**Subject:** Response to U.S. EPR Design Certification Application RAI No. 266, FSAR Ch 6, Supplement 4  
**Sent Date:** 2/25/2010 7:01:46 PM  
**Received Date:** 2/25/2010 7:01:50 PM  
**From:** DUNCAN Leslie E (AREVA NP INC)

**Request for Additional Information No. 266, Supplement 4**

**U.S. EPR Standard Design Certification**

**Application Section: FSAR Chapter 6**

**Figure 06.02.01.03-2-1—Decay Heat Comparison**  
**(Best-Estimate – No Uncertainties)**  
**(Equilibrium = 10 % U-238 – 30 % Pu – 60 % U-235)**

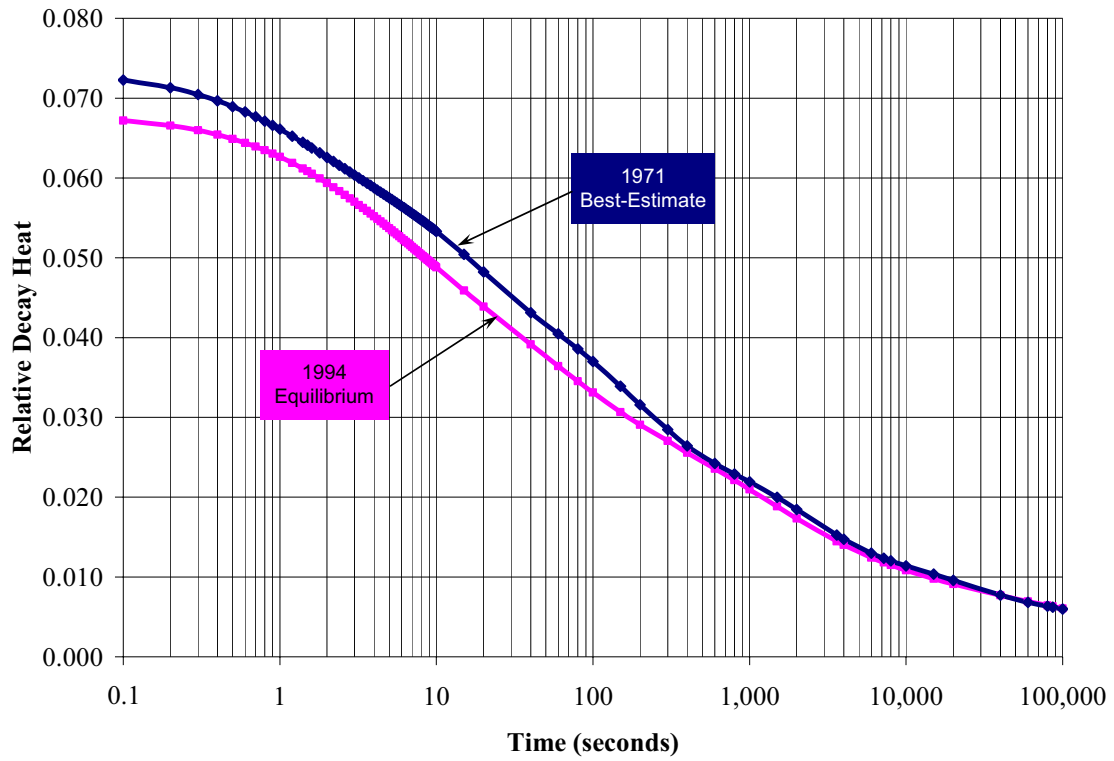
This question relates to mass and energy release analysis for postulated loss-of-coolant accidents in accordance with SRP Section 6.2.1.3. In RAI #82 6.02.01.03-p the staff requested that AREVA provide justification for decreasing the core decay heat multiplier from 1.2 to 1.1 in the mass and energy release calculations for the long term post reflood phase. In the containment mass and energy release calculations for the EPR, AREVA uses the 1971 ANS standard with a 1.20 multiplier for the first 1000 seconds. After that a multiplier of 1.10 is used. AREVA presented a comparison of the decay heat from the 1971 ANS standard using the 20 and 10 percent multipliers with the 1979 ANS standard using a  $2\sigma$  multiplier. The staff has recently accepted containment mass and energy release calculations using the 1979 ANS standard with a  $2\sigma$  multiplier. The 1979 ANS standard has a more extensive data base than the 1971 standard and is considered to be the more accurate. AREVA concluded that the core decay heat used in the mass and energy calculations for the EPR containment analysis is conservative compared with the 1979 ANS standard with a  $2\sigma$  multiplier and is therefore acceptable. AREVA extended the comparison to 10,000 seconds. The staff obtained a similar result for the first 10,000 seconds. At times greater than 20,000 the staff found the 1979 ANS standard with a  $2\sigma$  multiplier to be the more conservative. In order to resolve this issue, demonstrate that the decay heat model used in the containment mass and energy calculations is conservative. In application of the 1979 ANS decay heat standard or later standards justify the input assumptions selected. These include assumptions for actinide decay, actinide production factor, multiplier to account for neutron capture activation, fissions per initial fissile atom and power history. The effect of these assumptions is discussed in NRC IN 96-39.

Figure 06.02.01.03-2-1 shows the comparison. The 1971 standard is conservative with decay heat values that are higher than those associated with the 1994 standard.

The actinide decay heat rates for both the 1971 and the 1994 standards are identical. The differences shown in Figure 06.02.01.03-2-1 are caused by the relative isotopic fission energy production rates in the 1994 standard. These rates reflect an equilibrium U.S. EPR fuel cycle design.

Figure 06.02.01.03-2-1 shows the conservative nature of the 1971 standard in comparison to the 1994 standard and confirms the industry assessment of decay heat (i.e., the 1971 standard has conservative biases). To further address this question, the comparison needs to be appropriate for LOCA analyses. Thereby, the " $2\sigma$ " uncertainties were applied to the Figure 06.02.01.03-2-1 values. These uncertainties reflect a 95 percent level of confidence that at least 95 percent of the data will be within the bounds of the mean decay heat value plus the product of the confidence factor ( $K = \pm 2$ ) and standard deviation (95/95).

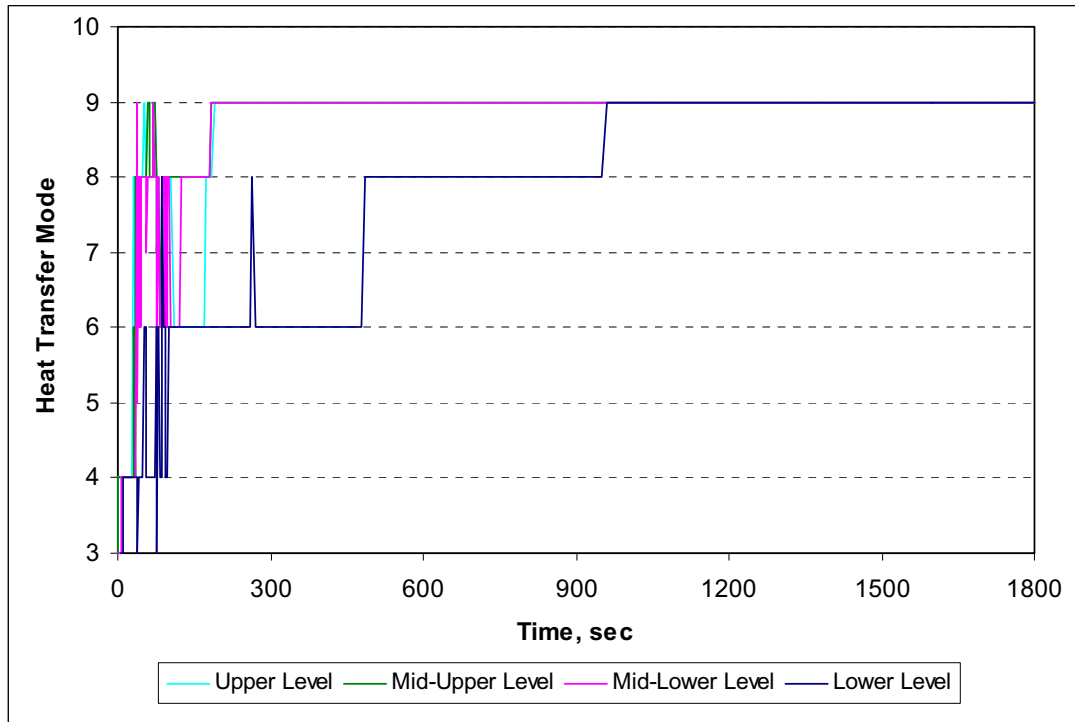
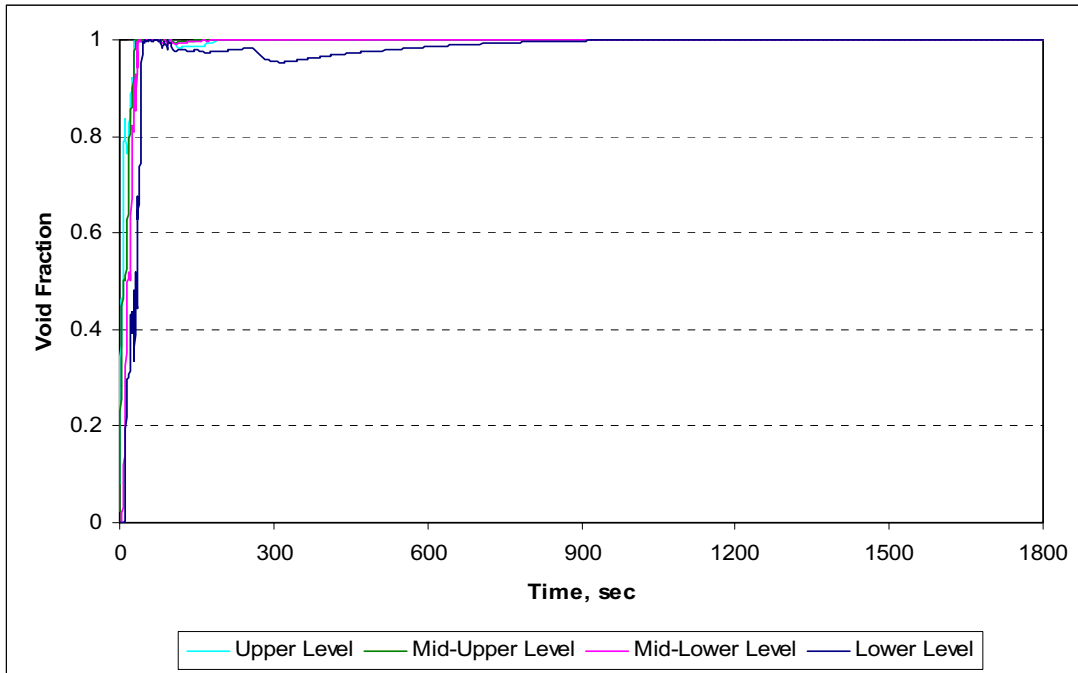
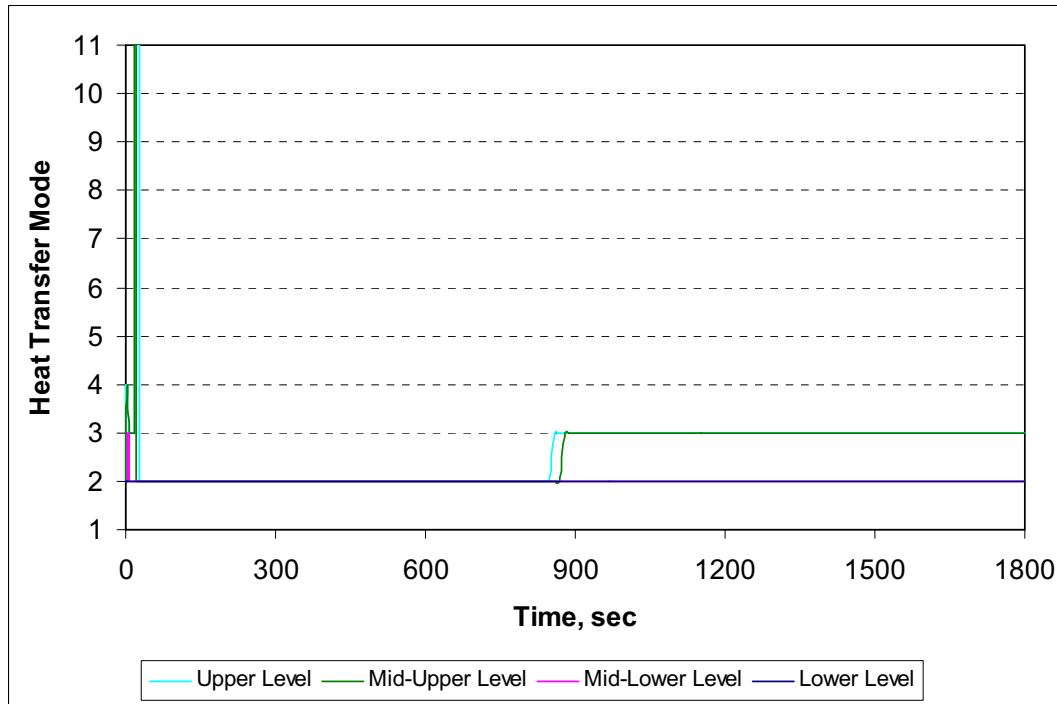
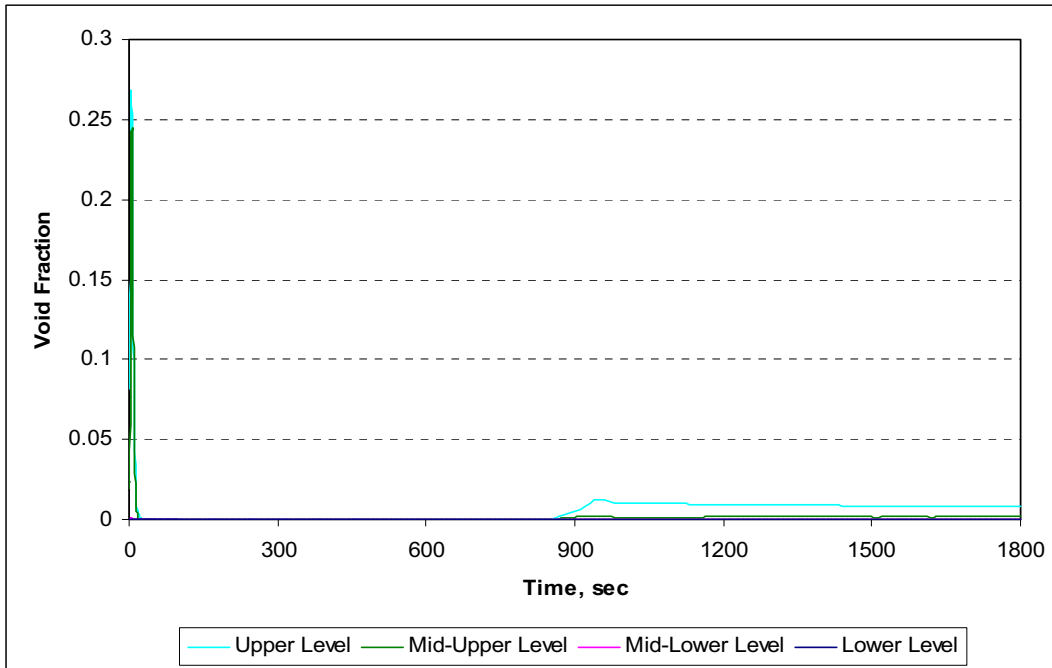
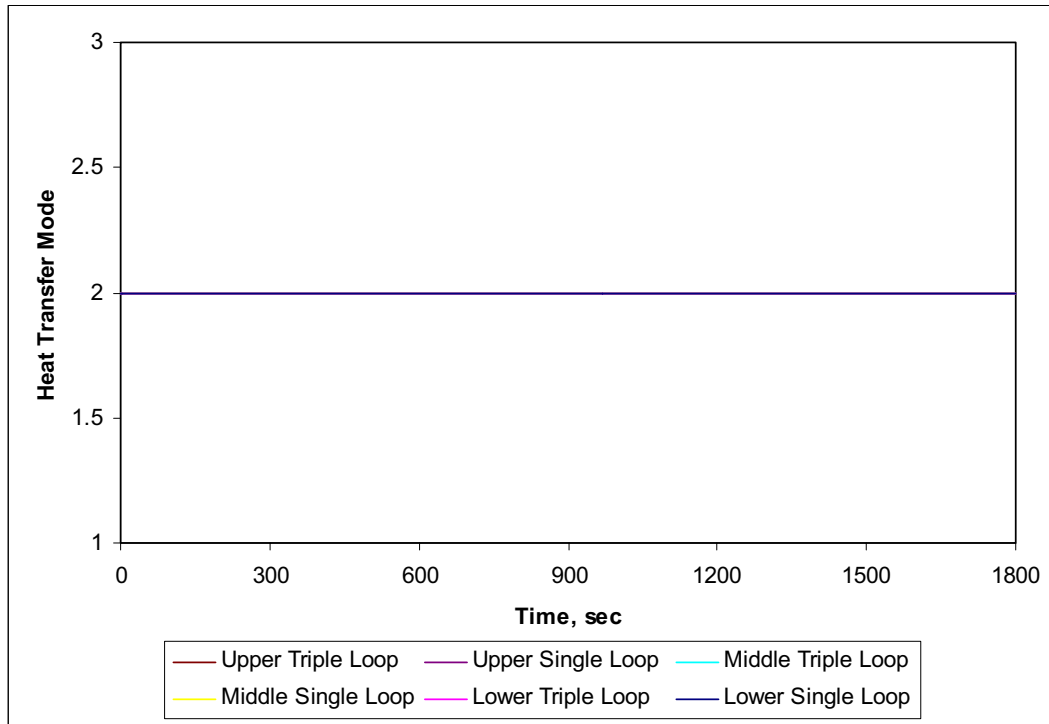
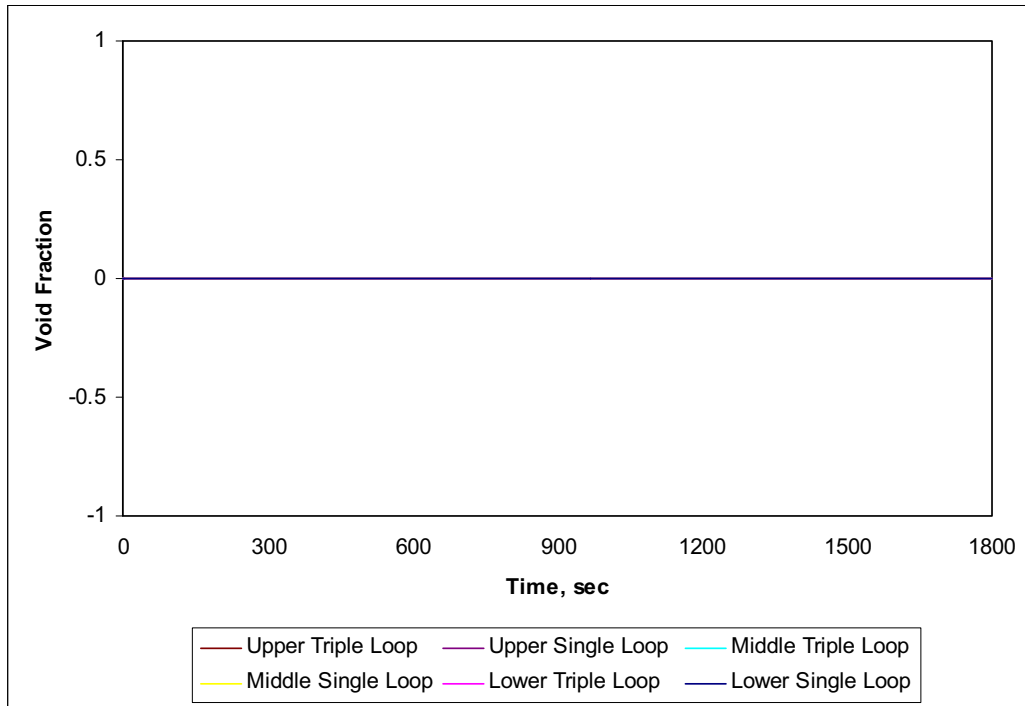
This question relates to conservativeness of the secondary system break mass and energy release calculations in FSAR Section 6.2.1.4. In response to RAI #82 6.02.01.04-1a Sup.1 AREVA described, in general, the heat transfer models in the RELAP5/MOD2-B&W computer code. AREVA did not designate which heat transfer correlations were used in the main steam line break mass and energy release calculations. The most significant locations of heat transfer are the heat transfer from the primary system to the two phase mixture in the affected steam generator, the reversed heat transfer from the unaffected steam generators to the primary system, and heat transfer from the core. Demonstrate that these processes are conservative for the US-EPR limiting MSLB case. SRP 6.2.1.4 recommends that calculation of heat transfer to the water in the affected steam generator should be based on nucleate boiling heat transfer. Demonstrate that nucleate boiling was assumed for the limiting case or provide justification for other assumptions.

**Figure 06.02.01.04-5-1—SG Dome Liquid Fraction**

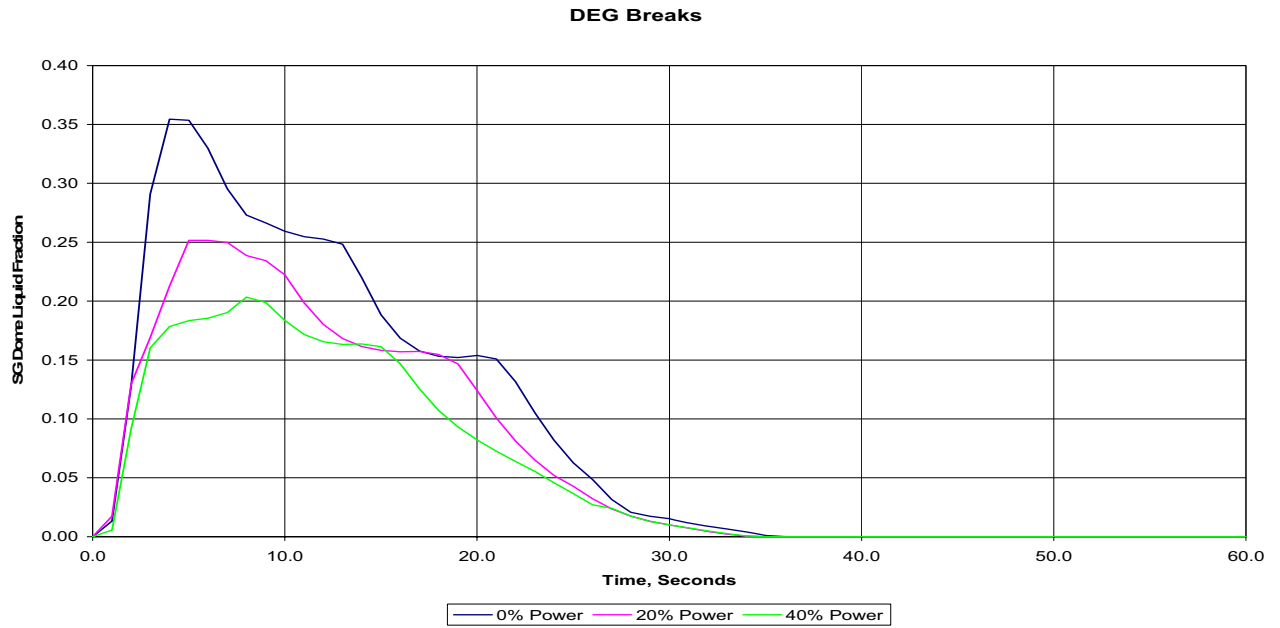
This question relates to conservativeness of the secondary system break mass and energy release calculations in FSAR Section 6.2.1.4. The staff understands that following a postulated main steam line break, if the liquid fraction in the steam separator region of the RELAP5-BW model exceeds a threshold value then entrained liquid is assumed to exit the break and to flow into the containment. If the liquid fraction in the steam separator region of the RELAP5-BW model is less than a second threshold value, any calculated entrained liquid is treated as steam. SRP 6.2.1.4 states that if liquid entrainment is assumed, experimental data should be provided to support the predictions. In the past the staff has accepted MSLB calculations with liquid entrainment based on model validation applying full scale steam generator test data. Provide experimental validation of the RELAP5-BW MSLB methodology or provide new analyses for which no liquid entrainment is assumed.

Therefore, the greatest liquid release occurs during the double-ended guillotine (DEG) break at a low initial power level, as shown in Figure 06.02.01.04-5.1. The containment response from these cases shows that the DEG break from 20 percent power is the limiting case for containment pressure (see Figure 06.02.01.04-5.2). Furthermore, the treatment of the liquid release using the AREVA method causes the limiting MSLB case of any break size from any power level to be the DEG break from 20 percent power. Therefore, the 20 percent power DEG case represents not only the limiting MSLB case with respect to liquid release, but also the limiting MSLB case.
